THEMATIC MAPPER

FLIGHT MODEL
PRESHIPMENT REVIEW
DATA PACKAGE
VOLUME III - SYSTEM DATA
PART C

HUGHES AIRCRAFT COMPANY
SPACE AND COMMUNICATIONS GROUP

3533000-400

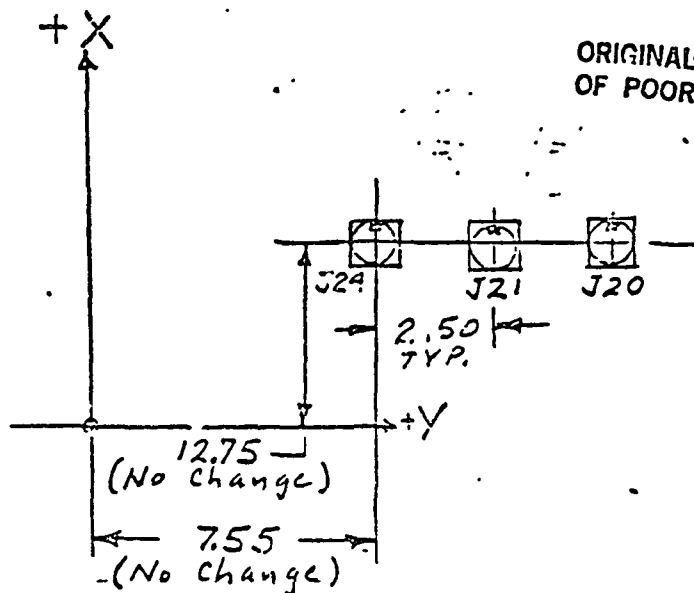
REVISE INTERFACE CONTROL DRAWING 3533000-400 TO REFLECT
REQUESTED CHANGE TO LOCATIONS OF ELECTRICAL INTERFACE
CONNECTORS J9 THROUGH J20 AND J24

THEMATIC MAPPER INTERFACE CONTROL DRAWING 3533000-400

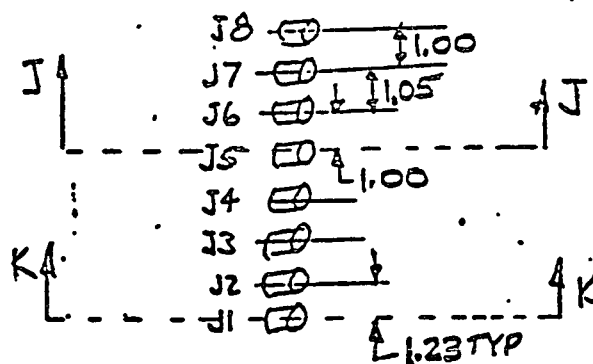
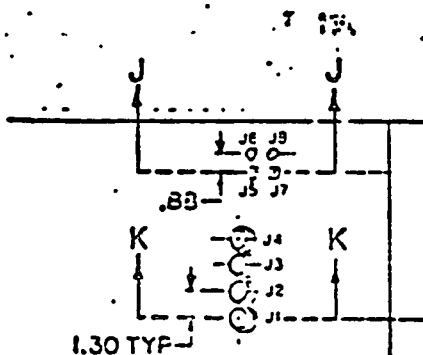
IS: 16.03 ± 0.08

IS: 20.93 ± 0.08

WAS: 16.25

THEMATIC MAPPER INTERFACE CONTROL DRAWING 3533000-400
SHEET 3 REV B

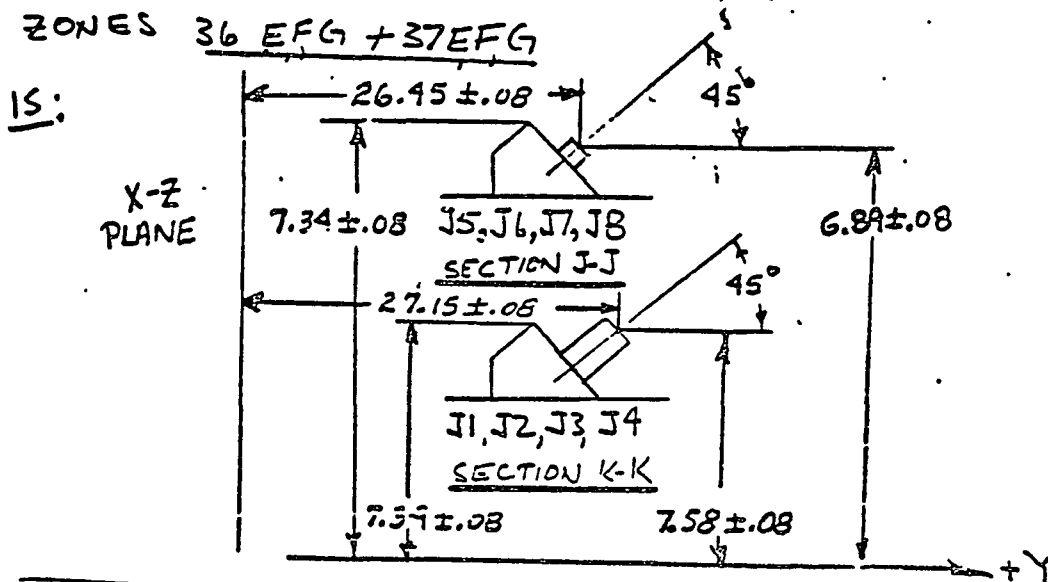
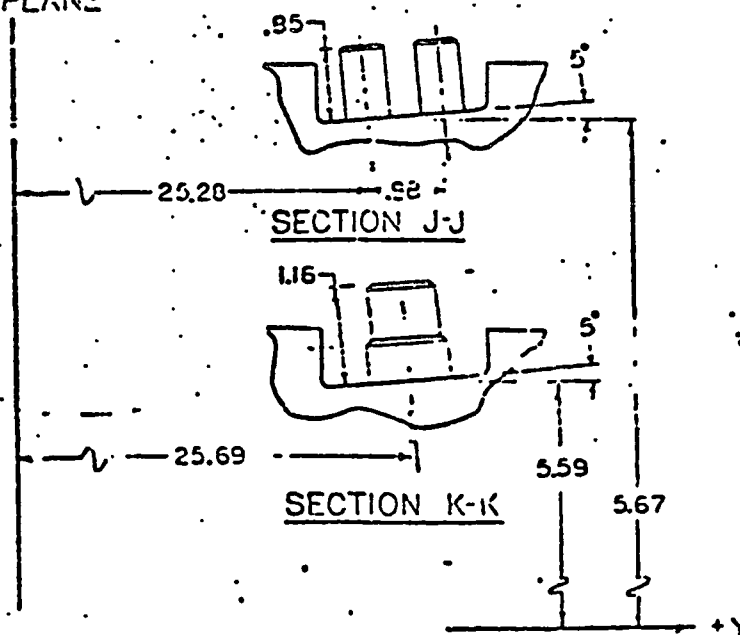
WAS:

SHEET 1

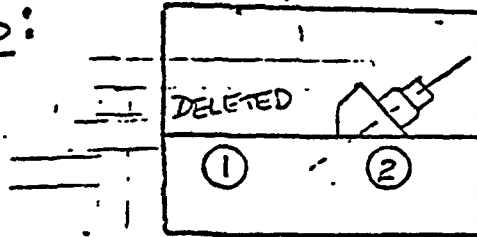
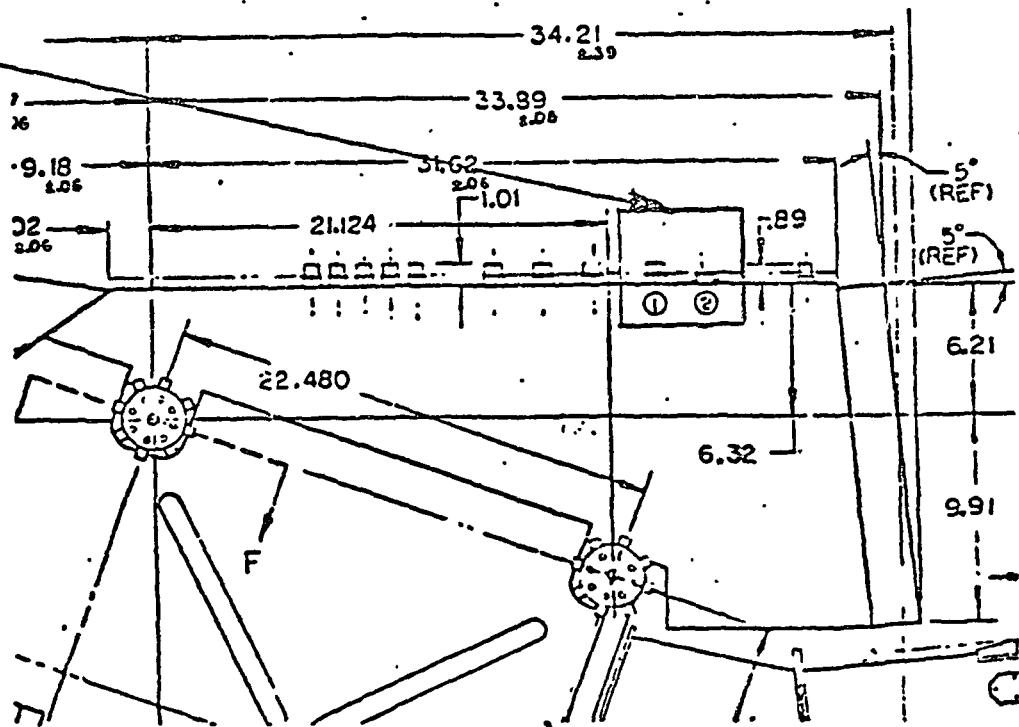
IS:

WAS:

THEMATIC MAPPER INTERFACE CONTROL DRAWING
3533 000 REV B SHEET 2

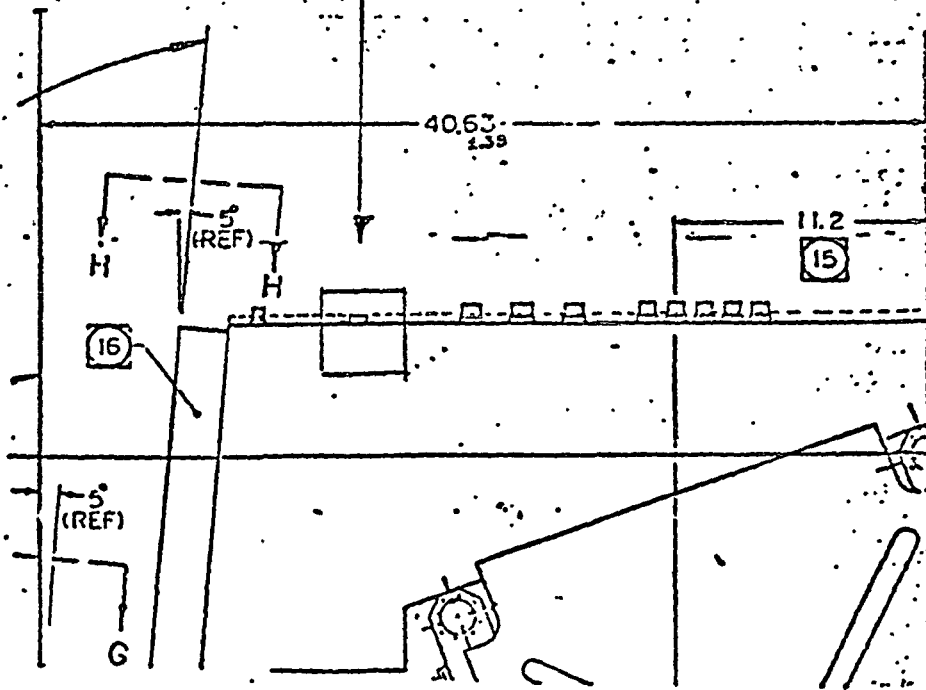
IS: ZONE 26F

VIEW L-L

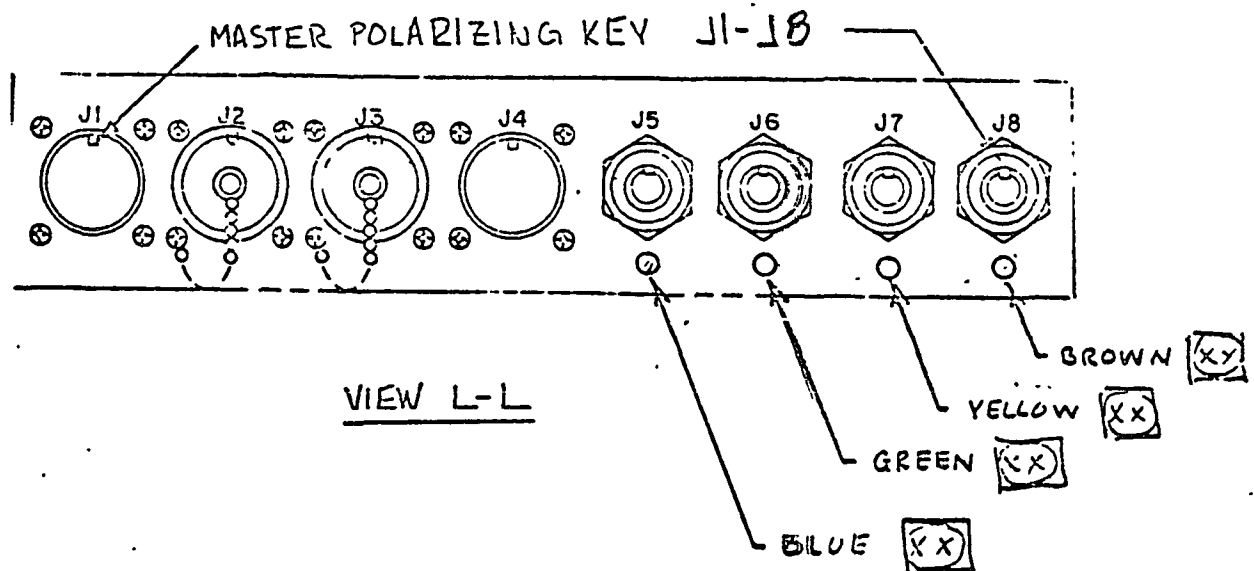
ADD VIEW L-L

Add Note

(X) "Spacecraft mating electrical connector shall be color coded with the same colors for J5 through J8."
